CITY OF CARMEL-BY-THE-SEA PLANNING COMMISSION

REGULAR MEETING Wednesday, March 9, 2022

- DS 21-180 (Janz): Consideration of a Concept Design Study for single-story additions totaling 545 square feet to a 1,385 square-foot single-story residence located at the northeast corner of Carpenter Street and 4th Avenue in the Single-Family Residential (R-1) District. APN 010-014-010-000 - CONTINUED TO APRIL 13, 2022

EXISTING CONDITIONS

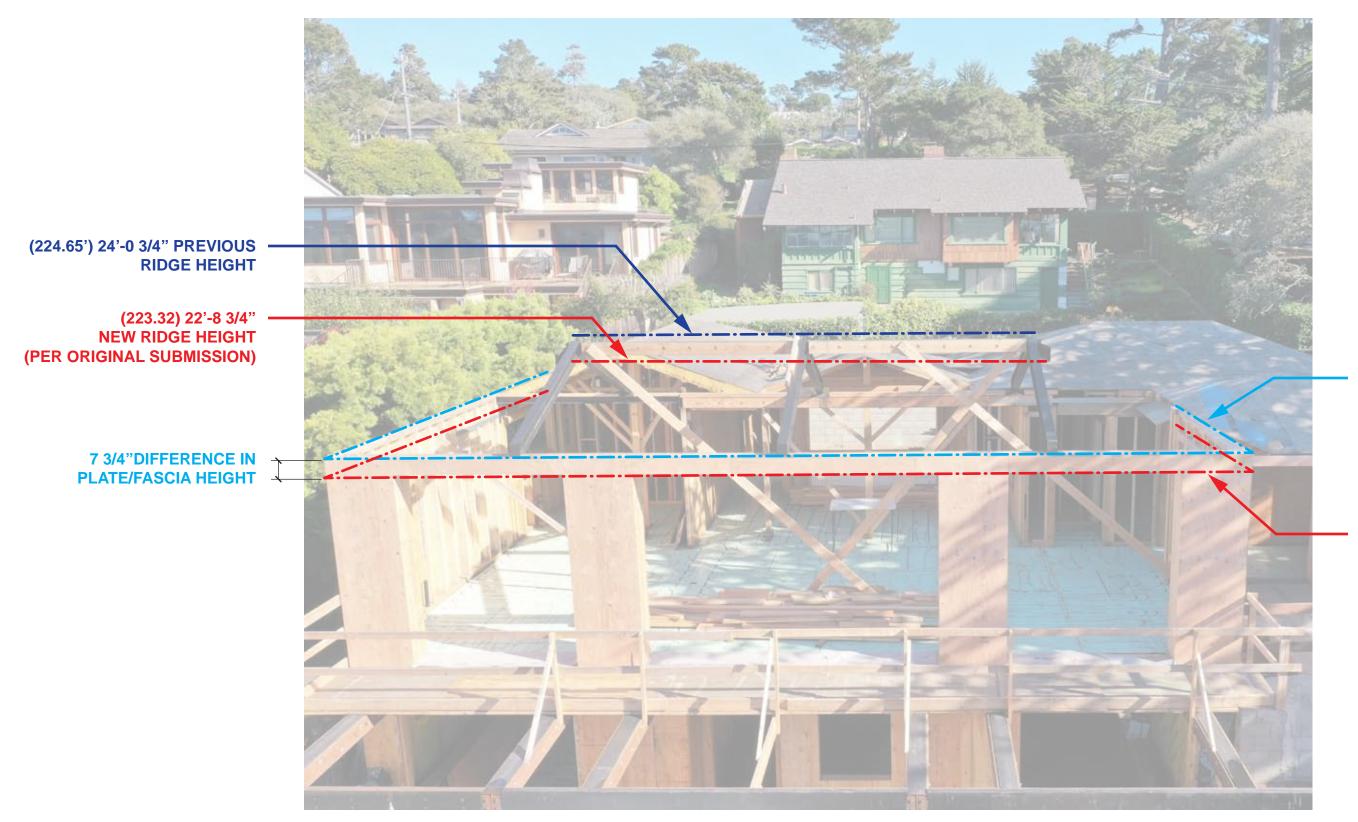
NEC SAN ANTONIO + OCEAN AVE LE CHIFFRE HOLDINGS LLC 03.09.2022 ELEVATION SHOWING AFFECT OF HIGHER PLATE HEIGHT ON ROOF FORM (223.32) 22'-8 3/4" NEW RIDGE HEIGHT (PER ORIGINAL SUBMISSION)

HEADERS ADDED ABOVE DOORS

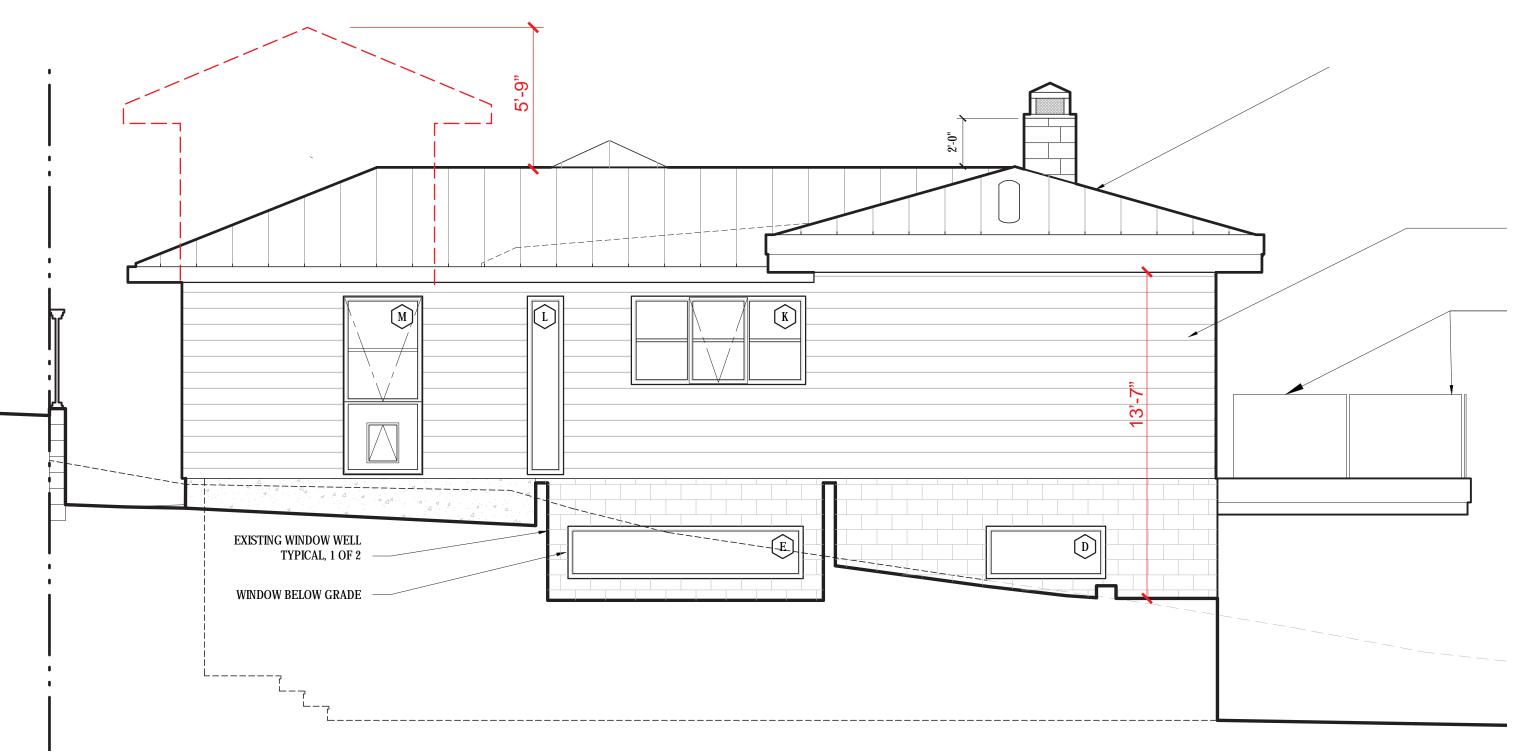
CLASH WITH DOOR HEADS IF PLATE IS LOWERED. NEW DOORS WOULD NEED TO BE ORDERED
